Safety Defect and Noncompliance Report Guide for Vehicles
AMENDED PART 573 Defect and Noncompliance Report

MCI Service Bulletin 344

All E model and J model coaches equipped with a DOGA windshield wiper motor.

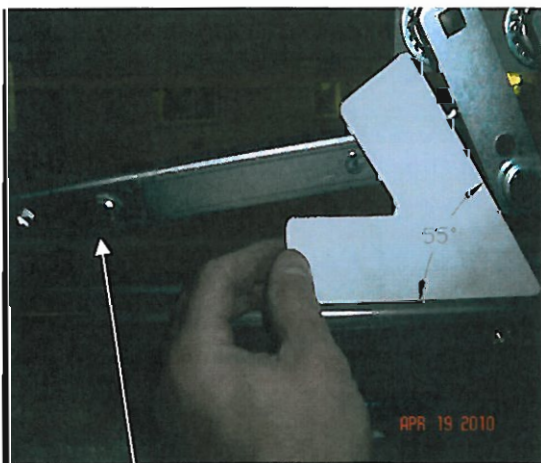
MCI will furnish the parts and labor required to implement the following DOGA-recommended remedies on the affected coaches:

1. Set the linkages of the arms to the recommended angle of 35 degrees from vertical as shown in the following photographs.
2. Install a bypass harness on the controller that prevents the controller from switching the motor to high speed. A schematic of this bypass harness is shown below.
3. Install a new DOGA model 259 motor in place of the model 258 motor. The 259 motor has a higher load capacity than the current 258 motor, which is intended to provide an additional safety margin to the wiper system.

Road side wiper arms, before and after adjustment.

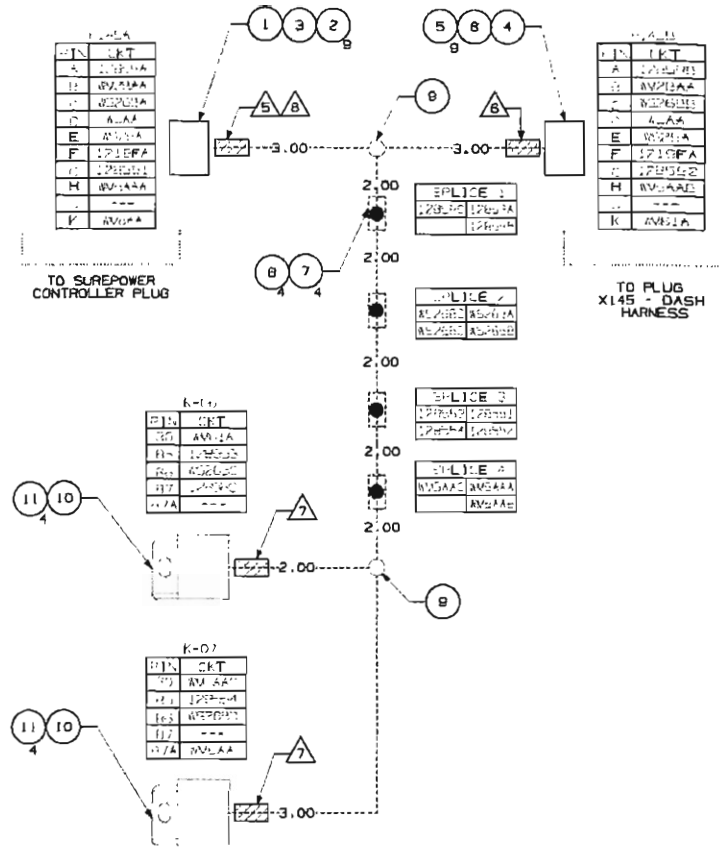
1. Adjustment of linkages to reduce torque on the motor.

Adjustment to the main wiper linkages is required so that the arm swing angle from the wiper arm pivot is 35 degrees on both sides vertical, which provides the optimal torque on the motor. Using an adjustment gage, the angle measured from the frame member is 55 degrees as shown.
